SHAKER HEIGHTS

Board of Zoning Appeals & City Planning Commission Agenda City Hall Council Chambers Tuesday, January 7, 2020, 7:00 PM

#2025. TAPAS LOUNGE/BAR – 16704 CHAGRIN BOULEVARD:

STAFF REPORT

16704 CHAIRS BLD
FRONT ENTRANCE

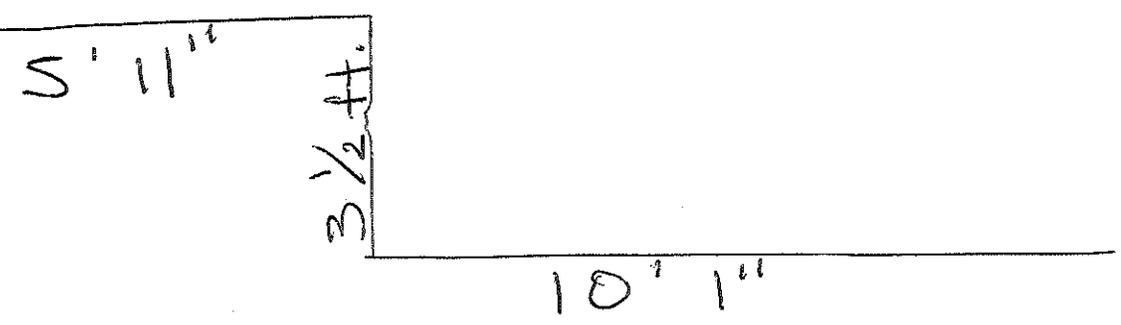
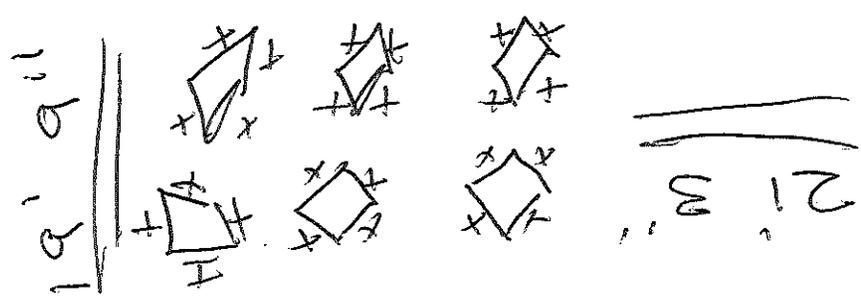
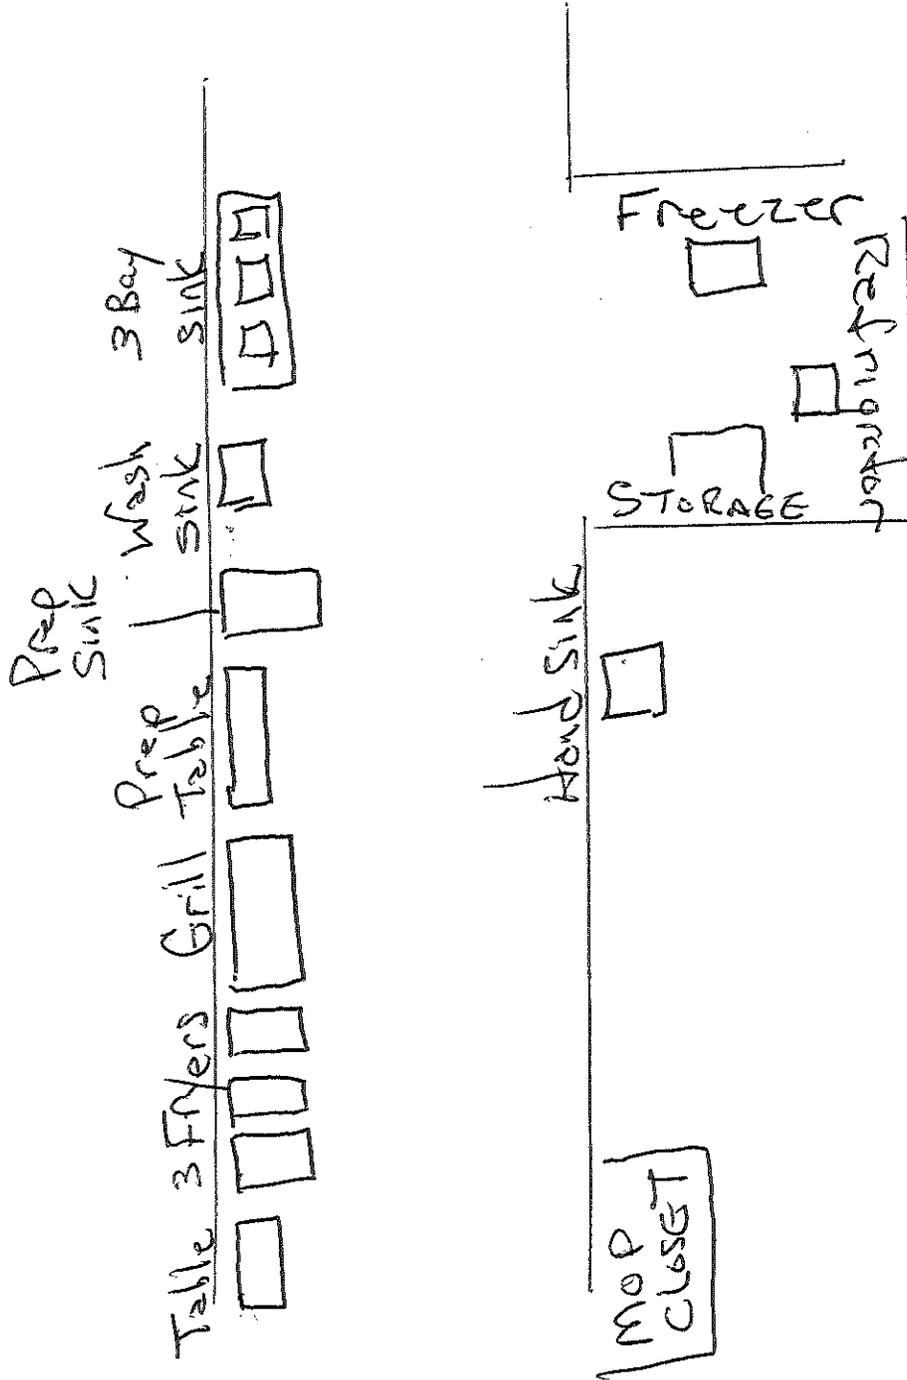
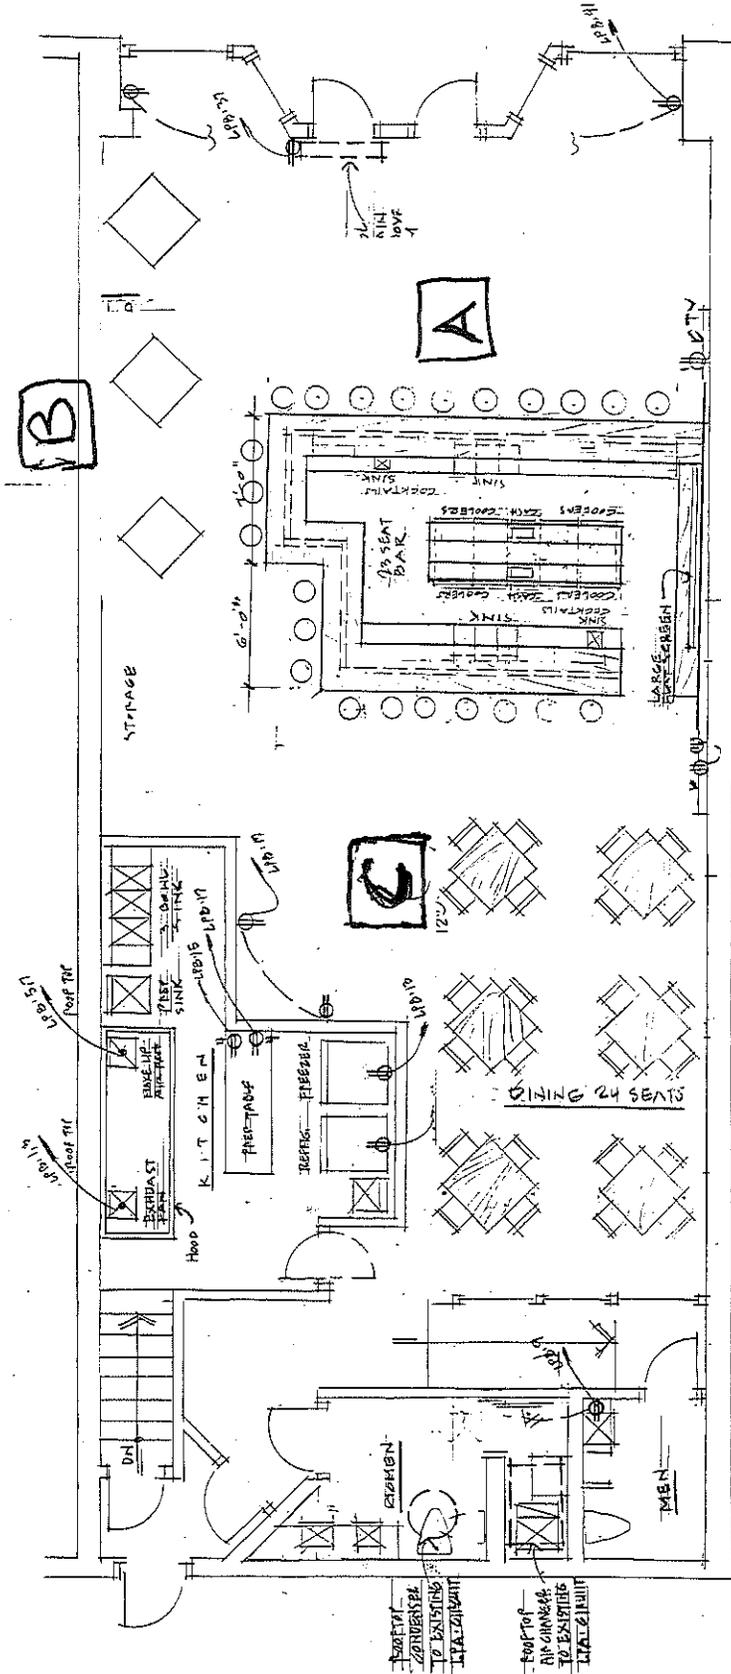
- Parking (denial)
 - No information has been submitted for current on-street or public parking lot counts, peak hour, and peak weekend hours usage.
 - The floor plan does not accurately show the existing floor plan, bar size, and seating arrangement on a to-scale drawing. The capacity (maximum occupants) of the space is not provided.

- b. A revised floor plan reflecting the existing condition and seat counts—**The floor plan has been altered but not revised to-scale. (A hand sketched seating plan has been submitted);** and

1. The property backs up to homes on Kenyon Road.
2. The submitted floor plan is not drawn to scale. While it may represent the number of seats, it does not show the bar size, location, and layout as built.
3. Much of the space has already been constructed. A portion of the work was done without a permit and much of the work was done on an erroneous permit, which was issued by the Building Department without prior zoning review. Currently, there is a stop-work order on the property.

- A revised floor and seating plan must be submitted because the floor plan does not match the partially constructed space, as the bar is larger than drawn on the plans.

- In addition, the number of seats, now 55, has been revised but not indicated by removing some high top wall ledge seating. An updated seat count must be provided with the revised plans.

ELEVATIONS
SCALE: 1/8" = 1'-0"

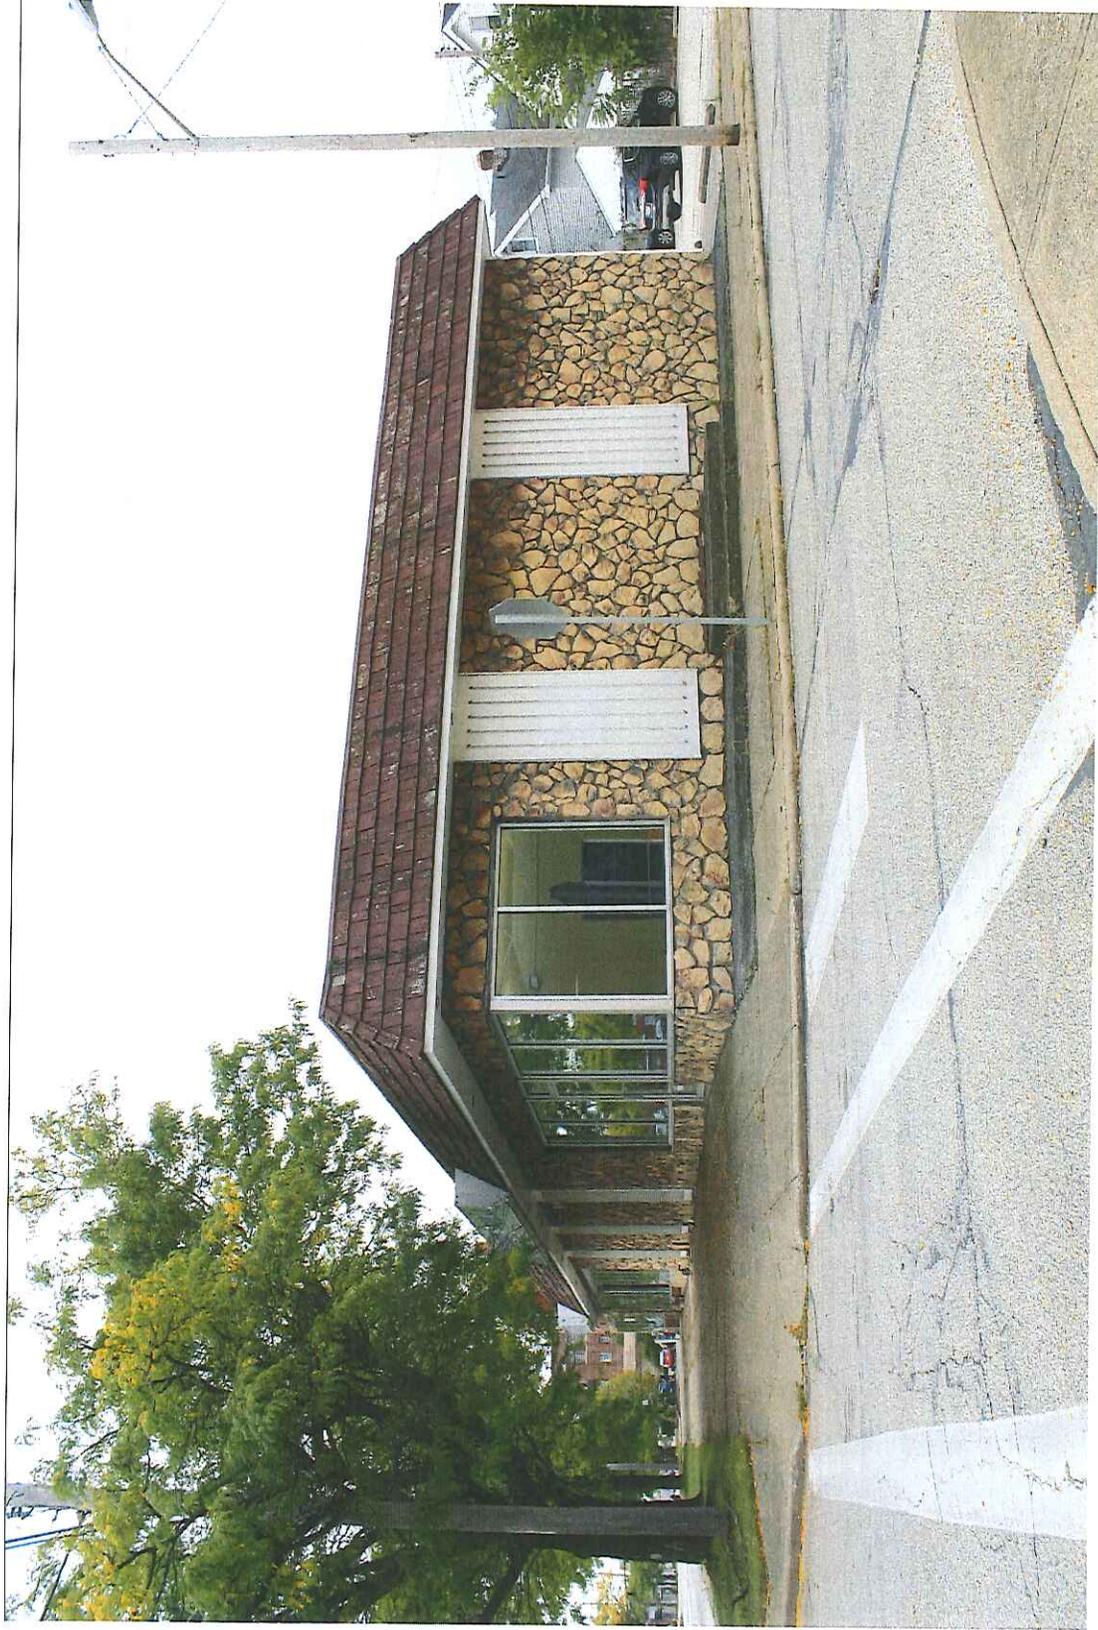
Mr. Neville asked how the planter will be constructed so the walls remain straight. He asked if there could be a plinth to keep the steel rainscreen elements above grade.

Mr. Feinstein said this storefront was reviewed at a previous meeting. There were questions regarding the proposed planter wall details.

Approved with the condition that construction details for the planters at 3700 Lee Road are provided for Board review.

Elicia Gibbon, architect, said there is integrated lighting added in the trellis awning, and LED strip lighting at the back flange of the screen wall supports. The screen wall will now be floating 4 inches off the sidewalk. The challenge to the planter design on the Nicholas Road side is to build around the existing stair unit. The planter will have a 6ml liner with stick built construction. The roots should not cause a problem as only low plants will be used here, under the windows. Where the container shape is more regular adjacent to the entry door, a PVC container will line the planter and larger plants can be used there.
